**Project: Pier A Windows and Doors  
Restoration, Repair and Replacement:  
General Contractor Services –  
Request for Proposals (“RFP”)**

**Date: January 5, 2024**

**Addendum #3  
# of Pages: 6**

**ATTACHMENT #1**  
**REVISED DRAWING A-002**

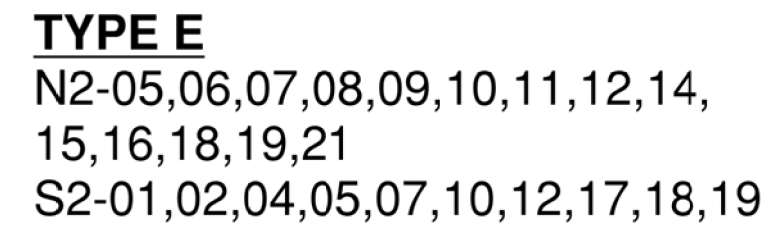
- All operable windows besides Type D shall be double-hung; only Type D shall be single-hung. Please see revised window schedule on Drawing A-002 – which, as stated in Section A (above), is appended hereto as Attachment #1.
